Product Change Notification

Model 3006 Trimpot® Trimming Potentiometer Packaging Improvement

Model 3006P

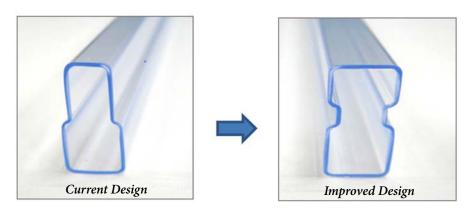
Bourns Trimpot Product Line announces a new design layout for the tube packaging of the Bourns® Model 3006 Trimpot® Trimming Potentiometer. This improved design provides a more secure fit for the model and increased stability in the shipping and handling process.

We will begin phasing in this process: December, 2013 First date code using the above changes: 1349
